**ST-HL-AE-5084**

**ATTACHMENT 6**

**LOSS OF ANY 13.8KV OR 4.16KV BUS**

HOUSTON LIGHTING AND POWER COMPANY  
SOUTH TEXAS PROJECT ELECTRIC GENERATING STATION  
PLANT PROCEDURES MANUAL

FIGURE 1. SECONDARY MASS

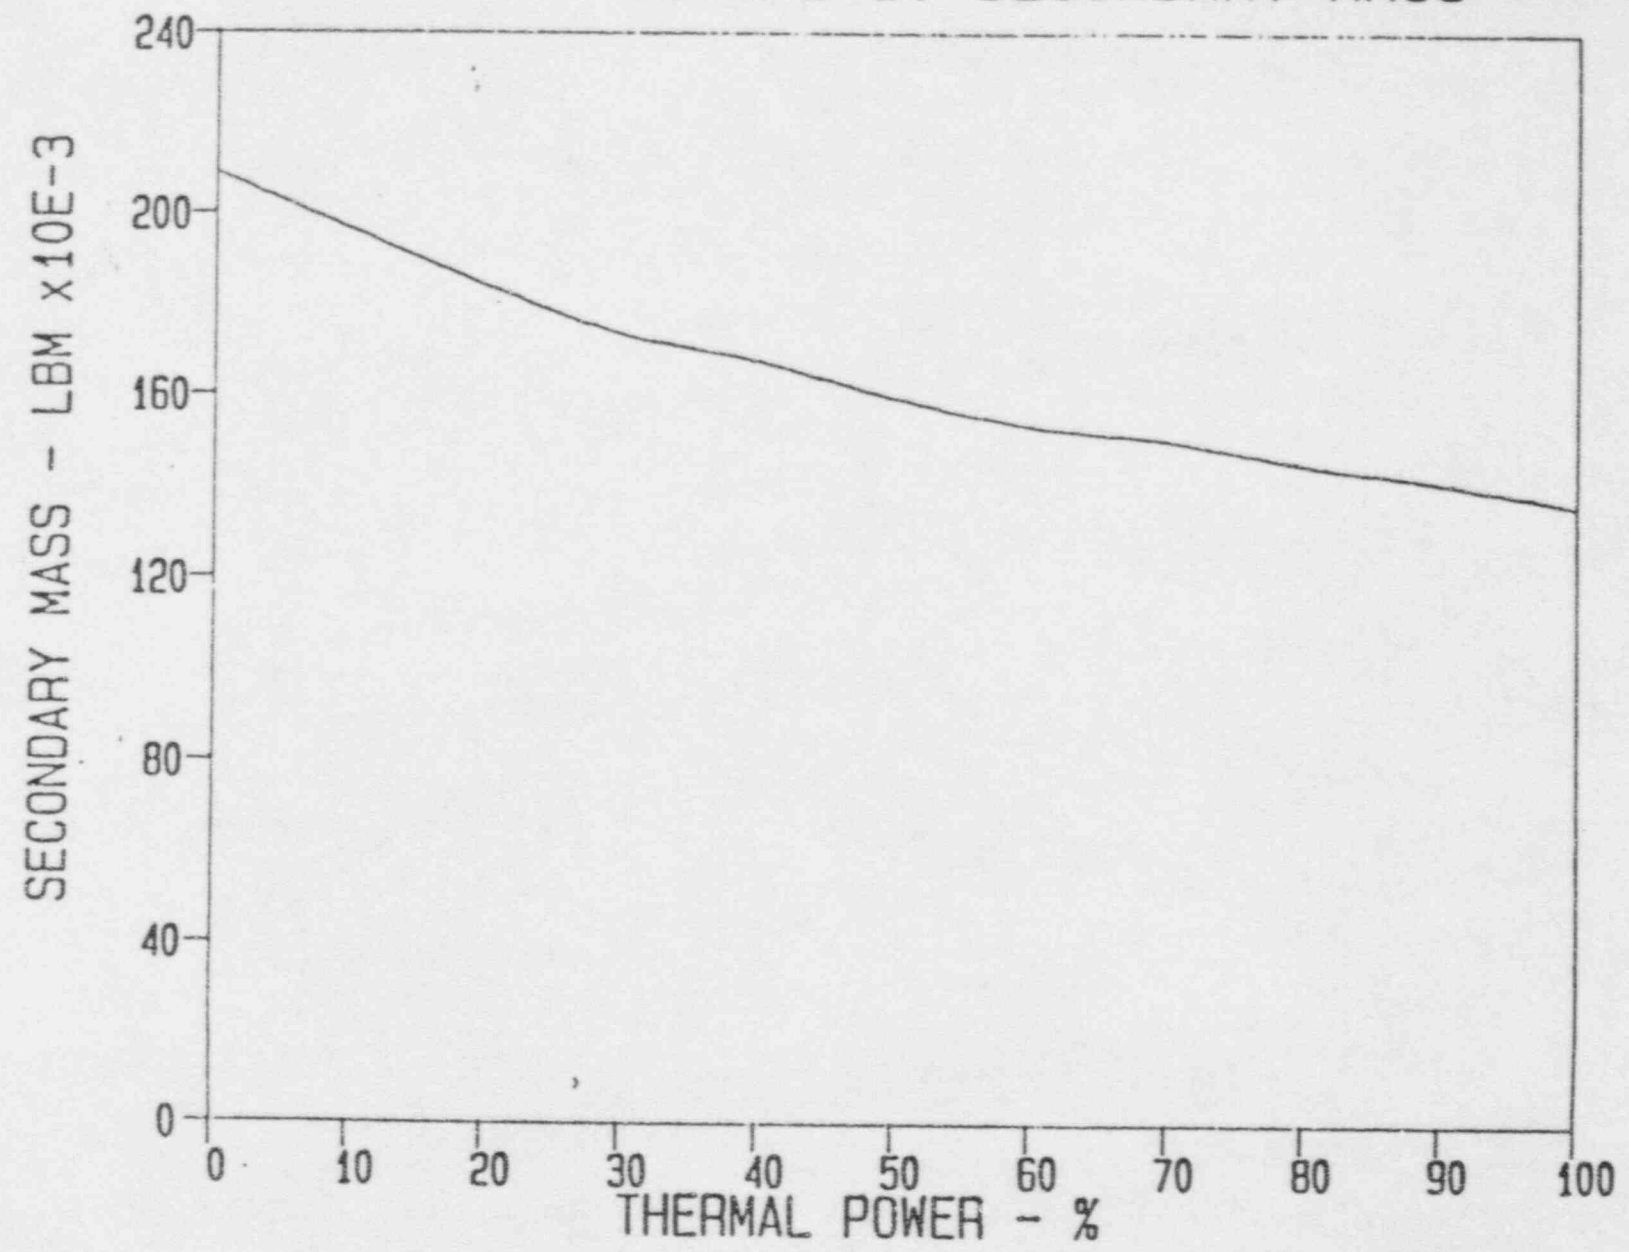
QUESTION 7:

Provide as a function of power the following items: secondary mass, circulation ratio, preheater leakage fraction, outlet temperature and qualities at various locations in the bundle.

RESPONSE:

Table 3 presents the information requested on page 16 and 27 of the questions. The following figures are also included which plot the indicated parameter vs percent thermal power:

- Figure 1 Secondary Mass
- Figure 2 Circulation Ratio
- Figure 3 Preheater Leakage Fraction
- Figure 4 Outlet Temperatures
- Figure 5 Outlet Qualities
